Sea Link

Volume 9: Examination Submissions

Document 9.129: Applicants Response to 2GEN1 and 2GEN2 in respect of Need

Planning Inspectorate Reference: EN020026

Plate 3.6: SC2 boundary fault and impact

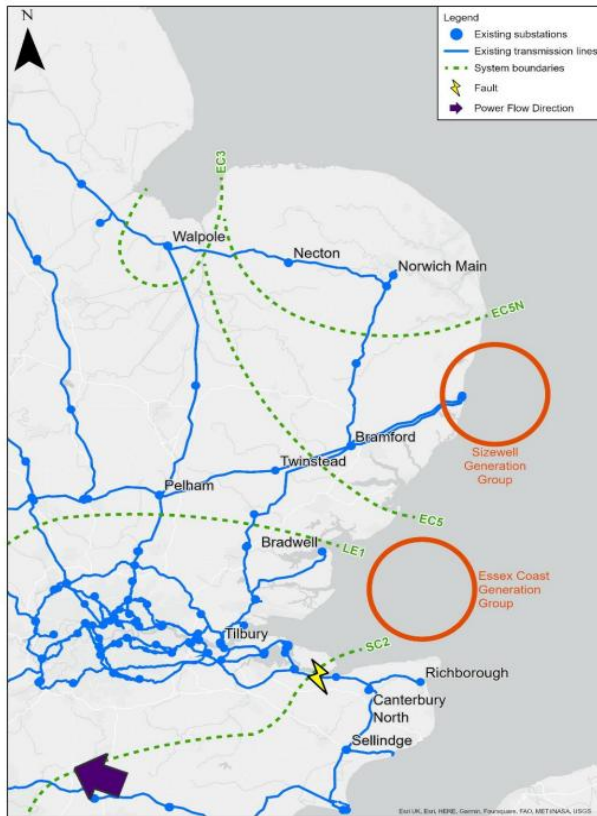
- 3.4.1 SEAS in **[REP4-156]** at para. 37 challenges the Applicant’s suggestion that part of the need case for Sea Link is to enable the export of electricity from Kent to Suffolk at times of high interconnector flows into Kent. SEAS’ argument is unfounded.

- 3.4.3 The “worst-case” fault for Kent would be a SC2 boundary fault as illustrated below in plate 3.6 from the Strategic Options Back Check Report **[APP-320]**:

- 3.4.4 The Strategic Options Back Check Report [APP 320] explains that “For the SC2 Boundary group the worst-case fault is for the double circuits connecting Canterbury North to Kemsley as shown in Plate 3.6, with the remaining circuit capability being 5,873 MW. The transfer required by 2037 following the closure of Dungeness Nuclear Power Station is 12,689.2 MW. This is in excess of both the capability and capacity of SC2 causing both overloads and voltage stability issues on the south coast” (paragraph 3.7.21).

- 3.4.5 Under the above fault in Kent, the Sea Link HVDC would export energy from Kent to East Anglia, as all circuits in East Anglia would be available as required by the NETS SQSS design standard. Under this required credible scenario Sea Link would export from Kent to East Anglia and therefore ensure compliance with the NETS SQSS.
